City of Turlock  
Well 38 Arsenic Mitigation  
And ICF Treatment

## **ADDENDUM NO. 1**

**FOR: CITY OF TURLOCK  
WELL 38 ARSENIC MITIGATION  
AND ICF TREATMENT**

**June 17, 2020**

##### **Sheet P50-02**

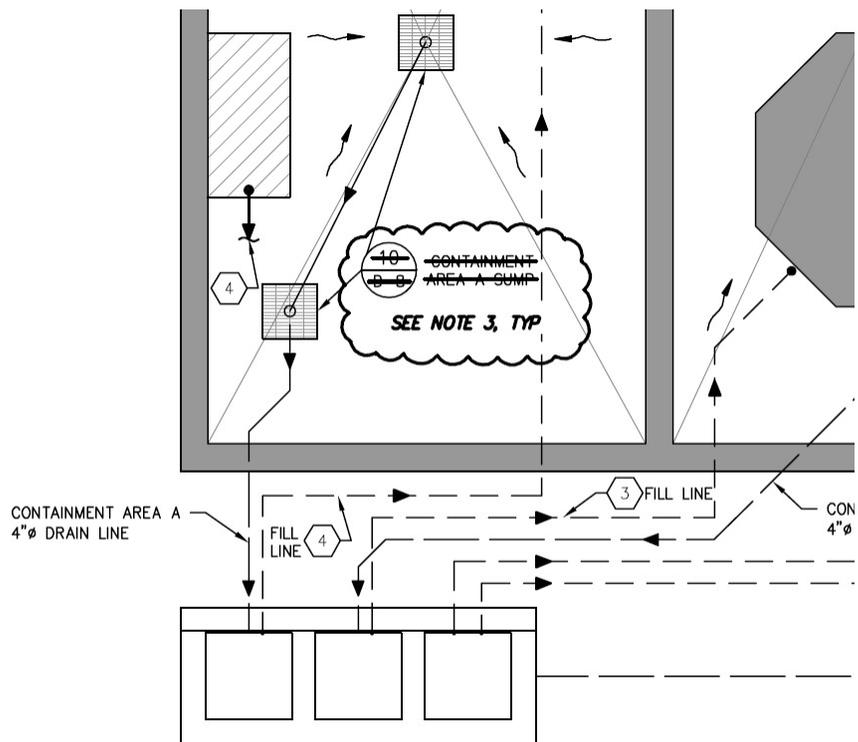
**Question No. 5:** On Sheet P50-02, Note 3 refers to chemically resistant floor drains but the callout on the drawing is a pre-cast box with steel grating (see Detail 10 on Sheet D-8). Please clarify what type of drain is to be provided.

Revise Sheet as follows Regarding Floor Drain Call Outs:

**Answer No. 5:** ***The chemically resistant floor drains per Sheet P50-02, Note 3 Shall be Provided. See Revisions to Plans Item 2 Below.***

##### **Sheet C-4**

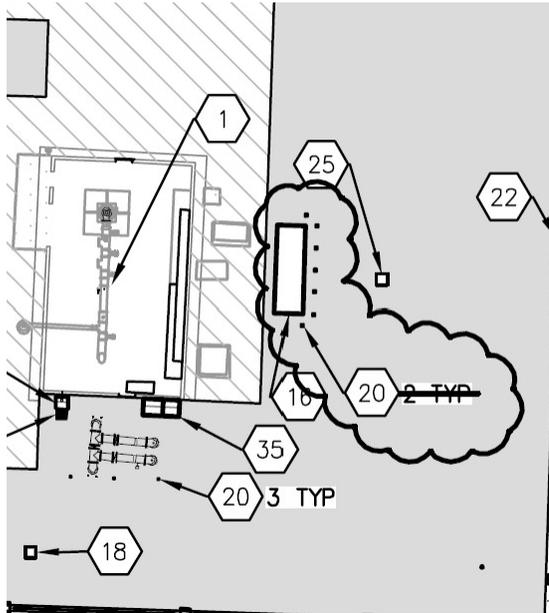
**Question No. 36: Call-out No. 20, Bollard, quantity two, on Sheet C-4 does not match the quantity of bollards shown on Sheet E2.1.**

Add additional bollards to the sheet as follows

**Answer No. 36: *See Plan Revision Item 5 in this Addendum.***

**Sheet P30-02**

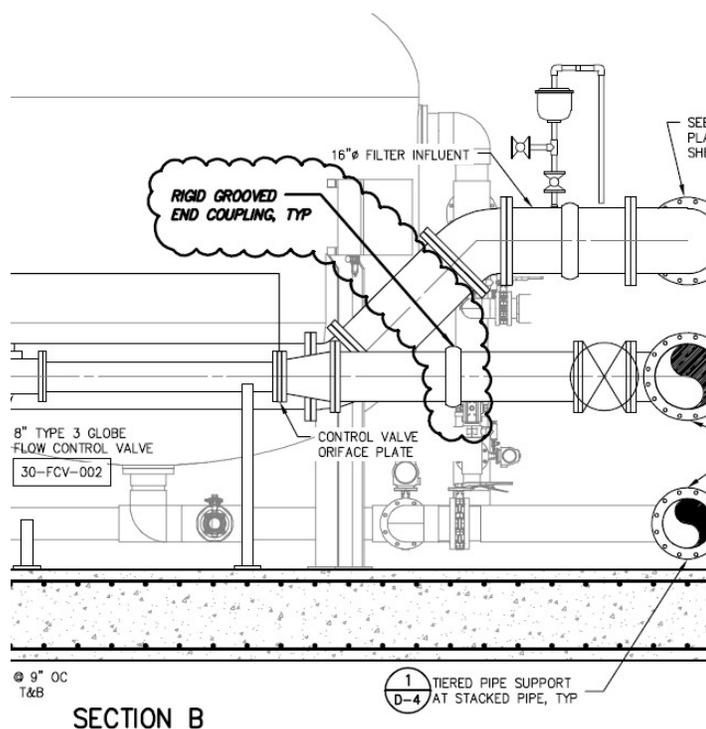
**Question No. 31:** Section C on Sheet P30-02 shows victaulic couplings installed on the 16"/12" filter influent line. These couplings are not shown on P30-01. Please clarify.

Add callout for Rigid Grooved Coupling as follows:

**Answer No. 31: Rigid Grooved End Couplings Shall Be Provided as Shown in P30-02. See Revised Item No 6 Provided in this Addendum**
